Access Compliance Report Public Rights-of-Way (RR Crossings)

Intersection ID: 10025402	Main Street: E_BLAND_ST	Location: N/A
ADA ID: 0B4D63781699	Overall Compliance: No	Severity Score: 0.0
Codes/Mitigation Info/Possible Solution		Field Measurements/Component Compliance

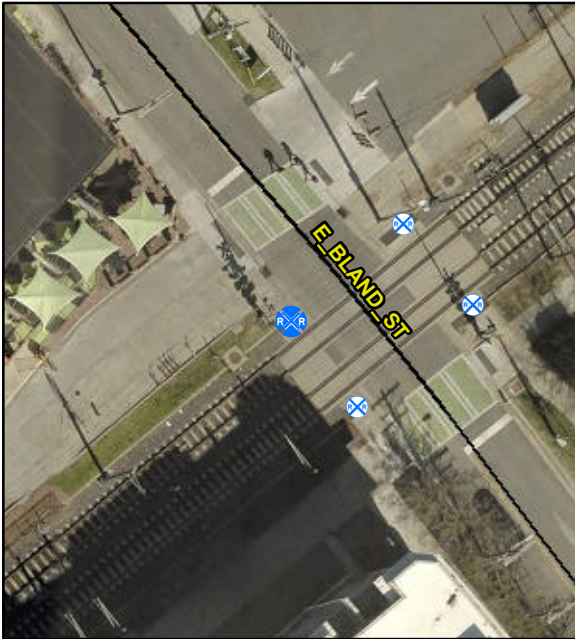
**Remove & Replace Detectable
Warning System. Remove & Replace
Walking Surface Adjacent to Rail.**

R302.7.4, R305.2.5

Compliance	Description	Data
Yes	DWS Provided?	Yes
Yes	DWS Contrast?	Yes
Yes	DWS Width (in)	Yes
Yes	DWS Length (in)	36.0
No	DWS Offset (in)	36.0
Yes	Pedestrian Gate?	Yes
N/A	DWS Outside Gate?	No
N/A	Rail Type?	LightRail
No	Flangeway Gap (in)	3.0
Yes	Sidewalk Width (in)	72.0
